THM 4L60-E/4L65-E "UPDATE HANDBOOK"

THM 4L60-E/4L65-E

THM 4L60-E TCC "PWM" SOLENOID ADDED IN 1995 AND NEW OIL PUMP ASSEMBLY FOR 1995

Figure 2

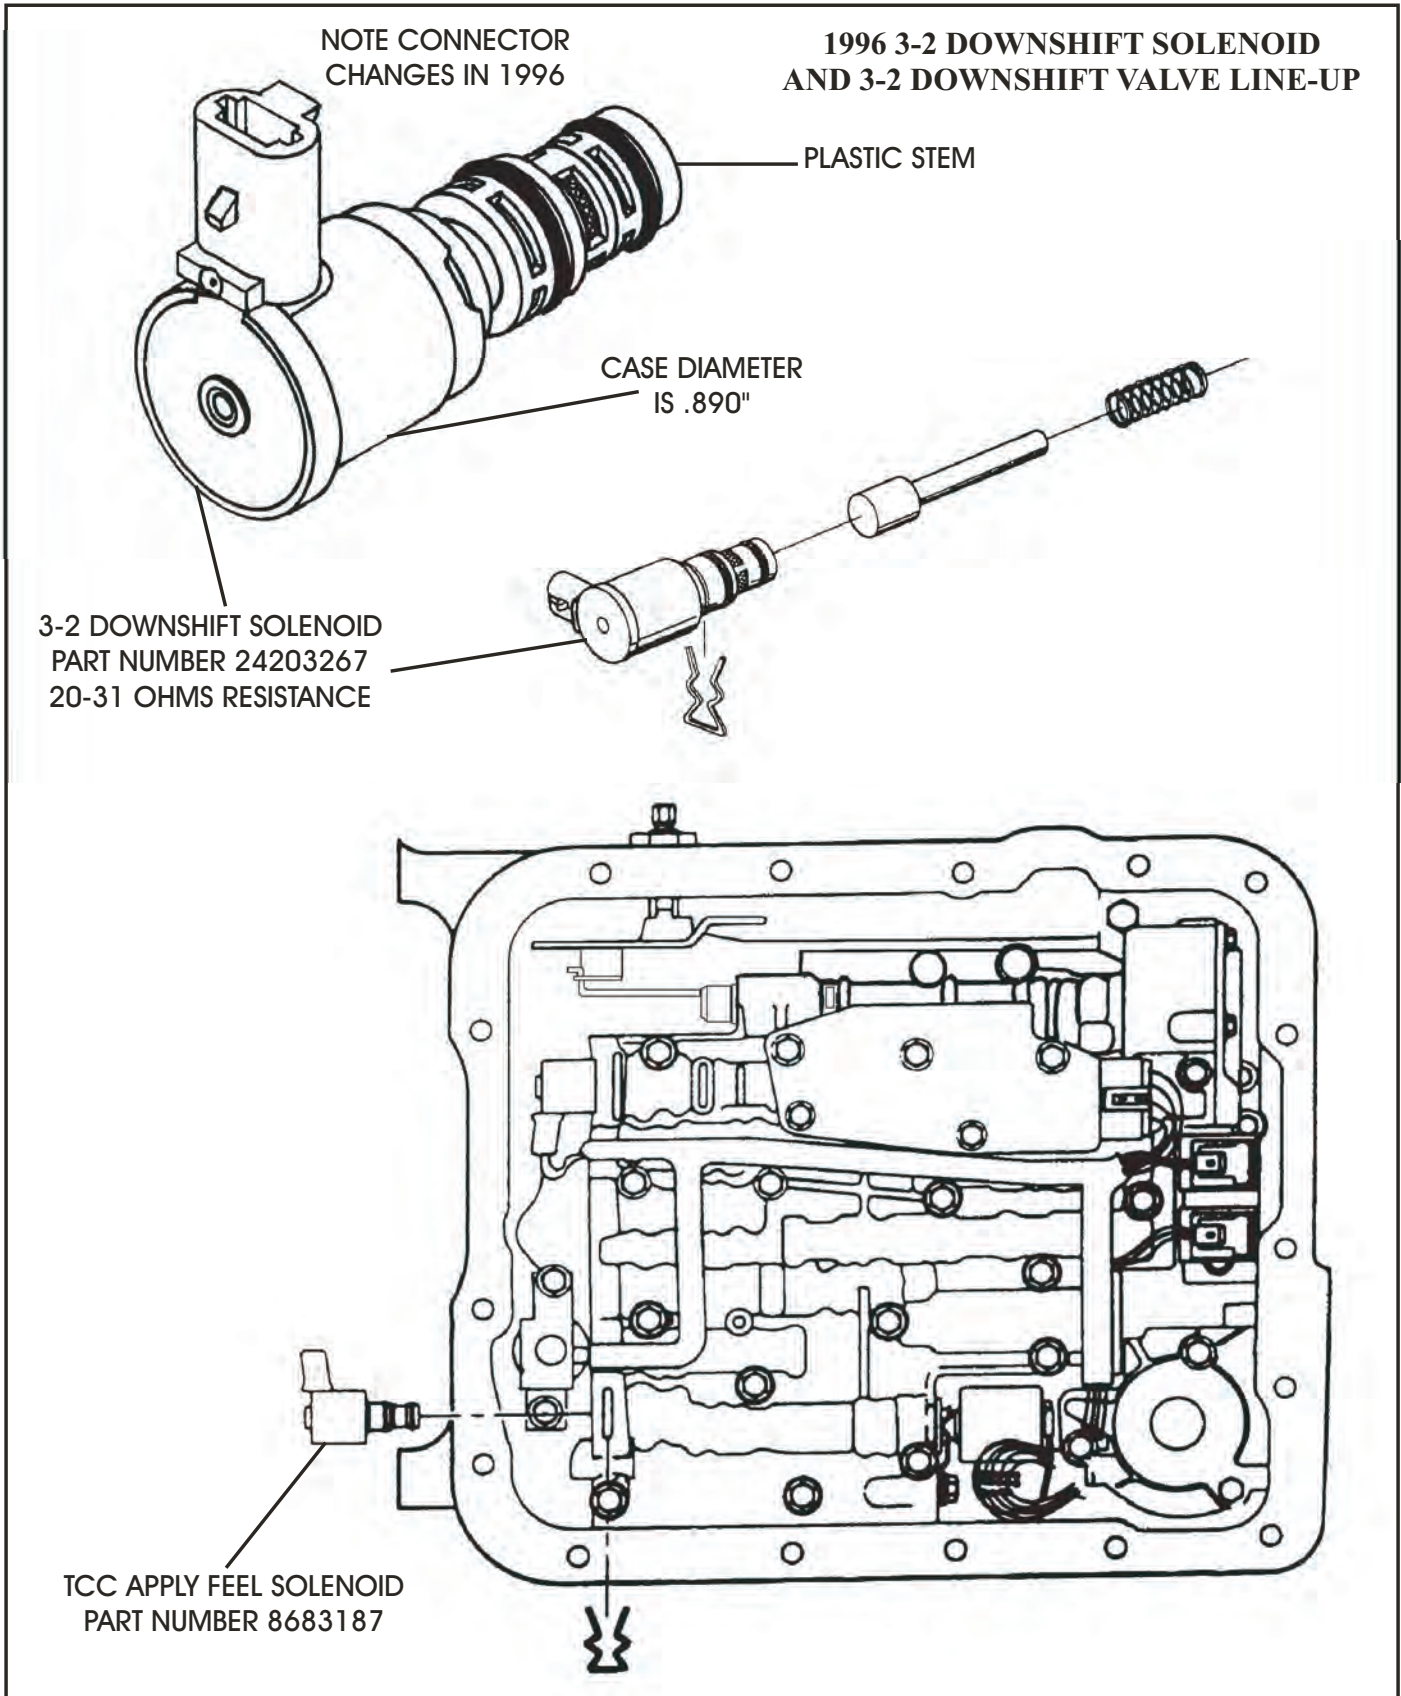
- (1) 3-2 DOWNSHIFT SOLENOID - Changes from a Pulse Width Modulated (PWM) solenoid to a regular "On-Off" (Normally Open) solenoid, which also requires a different Powertrain Control Module (PCM). The new design "On-Off" 3-2 downshift solenoid can be identified by the case diameter, which is smaller than the previous design, and the new design solenoid also has a *plastic* stem that fits into the valve body bore, where the previous design was *metal*.
The solenoid connector was also changed to prevent the solenoids from being accidentally installed in the wrong models. Refer to Figure 1 for 1995 models, and Figure 2 for 1996 models.

- (2) 3-2 DOWNSHIFT VALVE - The entire 3-2 downshift valve line-up changes to accommodate the new design "On-Off" 3-2 downshift solenoid. Refer to Figure 1 for 1995 models, and Figure 2 for 1996 models.

Figure 4

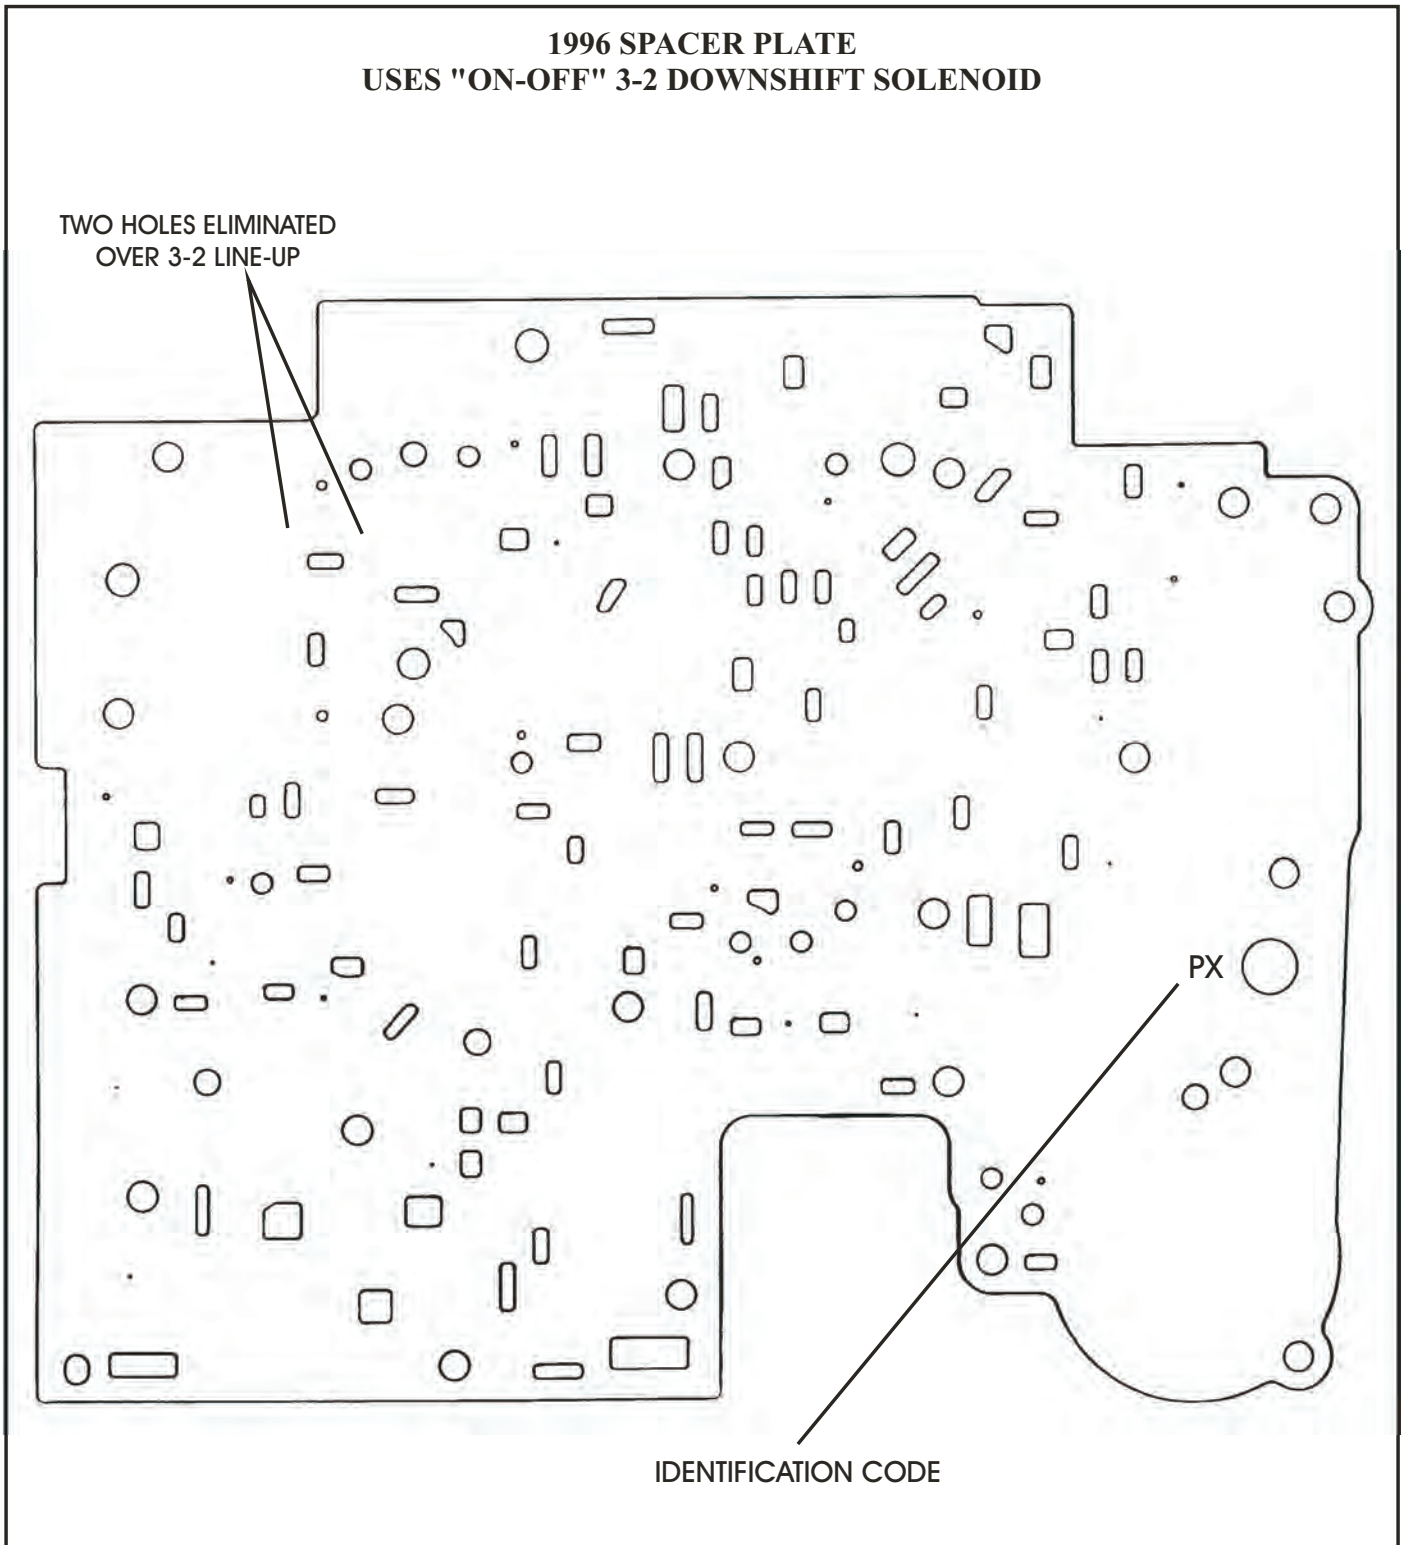
- (3) VALVE BODY SPACER PLATE - There were two holes eliminated in the 1996 spacer plate, over the 3-2 downshift valve line-up, to accommodate the new design 3-2 downshift valve. The 1995 spacer plate can be identified with the first letter of the two digit code being either an "M" or "N", as shown in Figure 3. The 1996 spacer plate can be identified with the first letter of the two digit code being a "P", as shown in Figure 4.

Figure 3

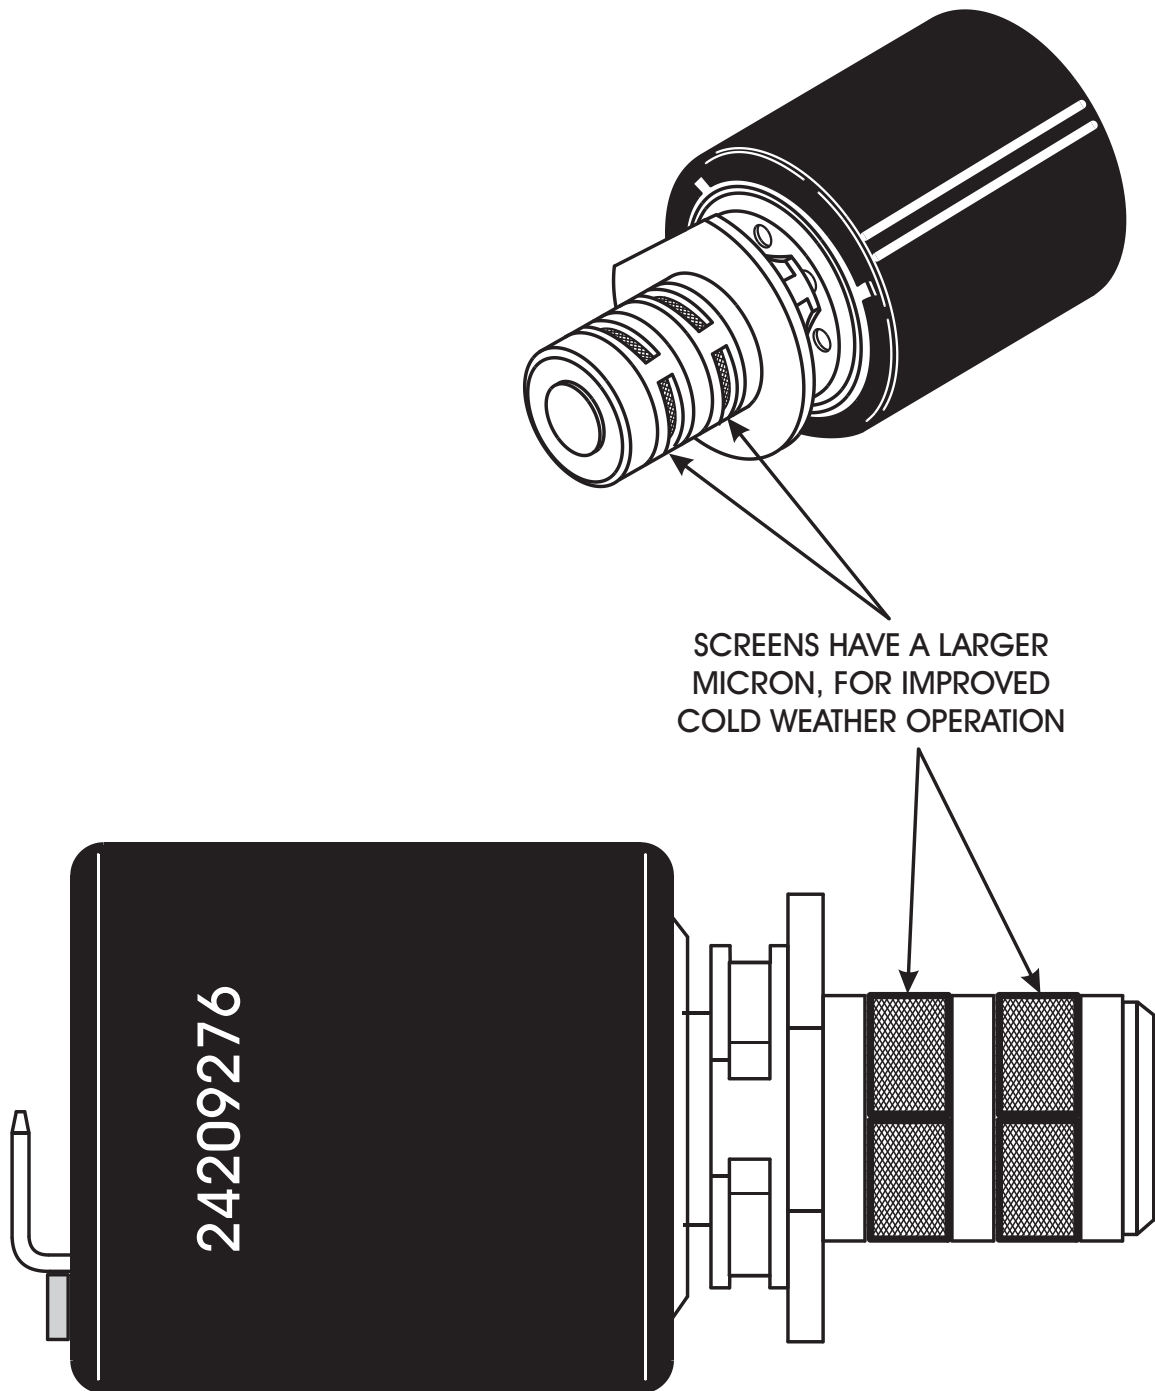
- (3) PRESSURE CONTROL SOLENOID - New design has larger micron screens in the solenoid to greatly improve cold weather operation. This will allow the colder oil through the screens easier. Refer to Figure 3.

Figure 1

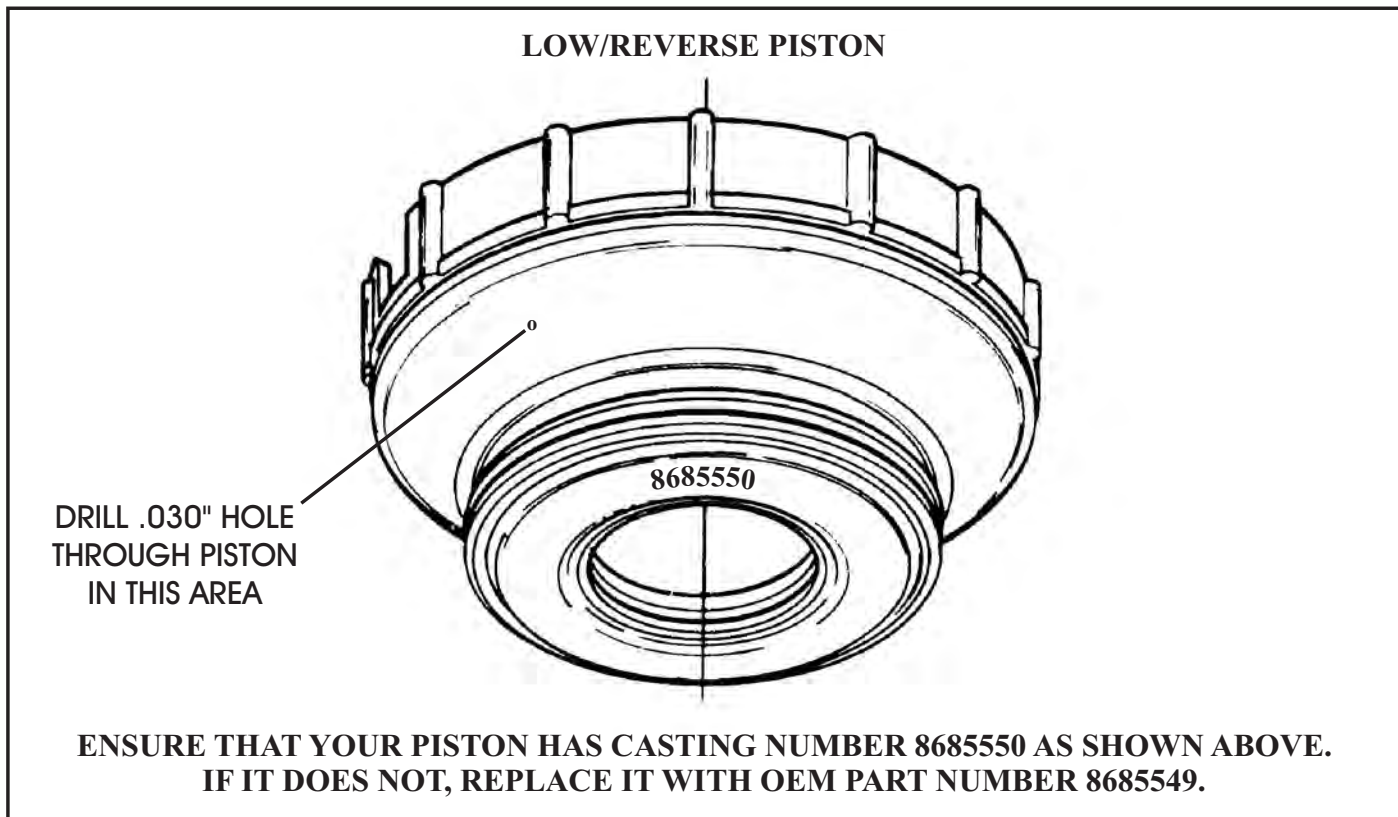
CORRECTION: STEP 1: Drill a .030" hole through the Low/Reverse Piston, in the tapered area between the outer seal and the center seal, as shown in Figure 1. This will provide an immediate exhaust path for PR apply oil when the selector lever is placed into the Drive position.

Figure 2

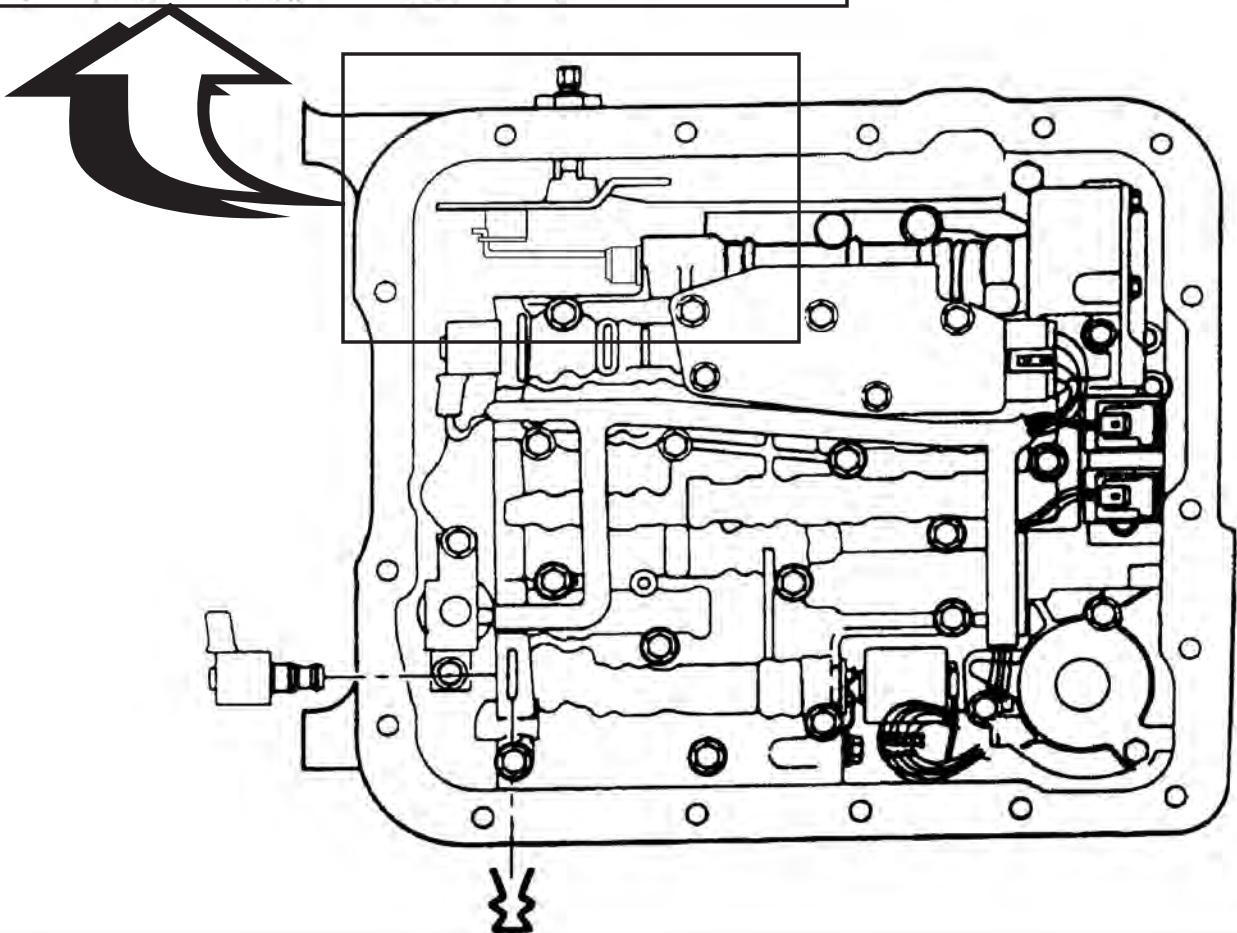
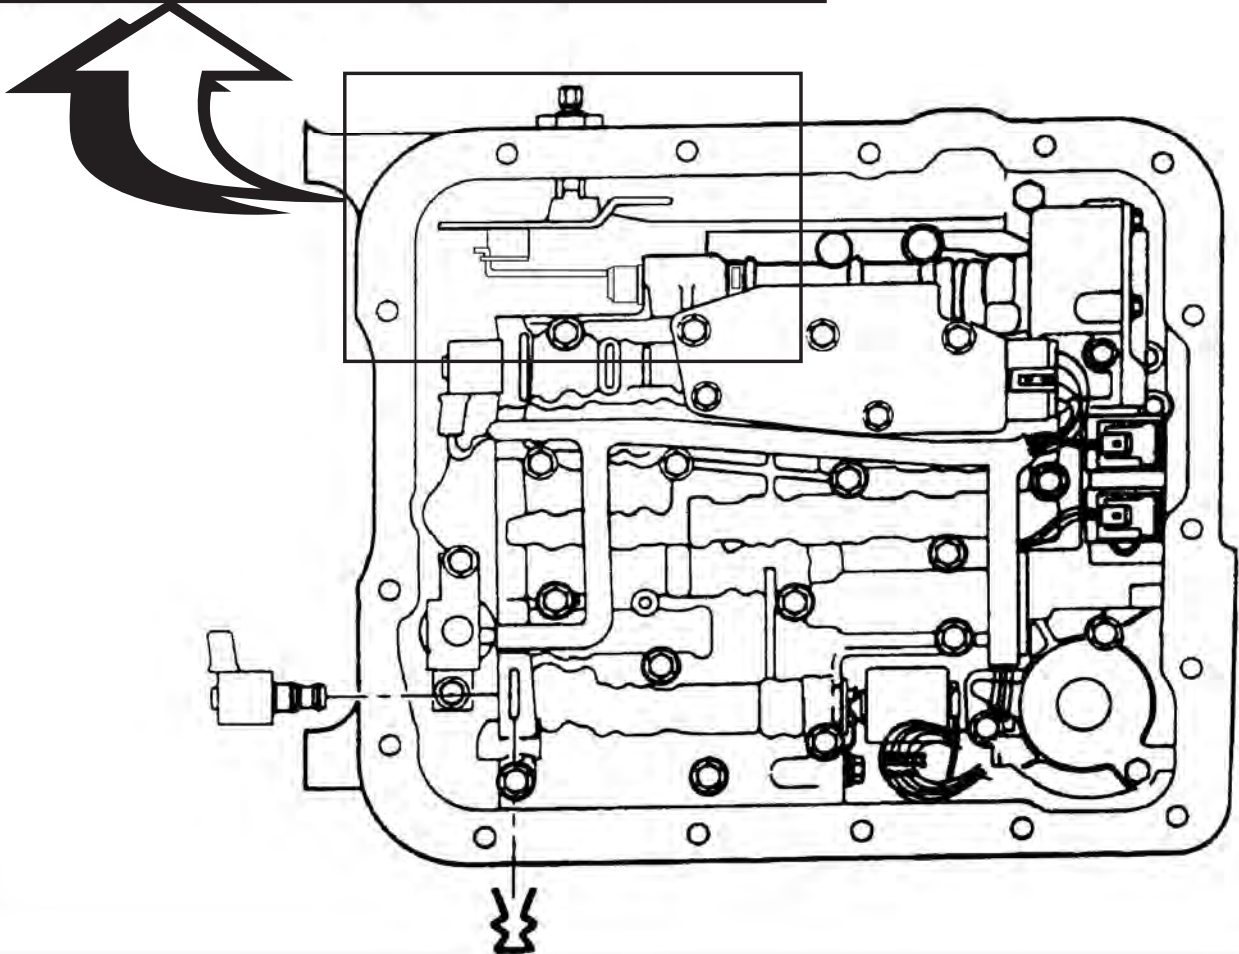
CHANGE: Beginning at the start of production for all 1996 models, the THM 4L60-E transmissions were built with a new design Manual Valve, and a new design Valve Body Casting. Refer to Figures 1 and 2.

- (1) **VALVE BODY CASTING** - Added exhaust hole through the valve body casting in the manual valve bore, to exhaust Lo/Reverse clutch oil at a faster rate when the manual valve is in the Drive position. Refer to Figure 1 for 1995 models, and to Figure 2 for 1996 models.
- (2) **MANUAL VALVE** - Totally different design to accommodate the added exhaust hole in the valve body casting. Refer to Figure 1 for 1995 models, and to Figure 2 for 1996 models.
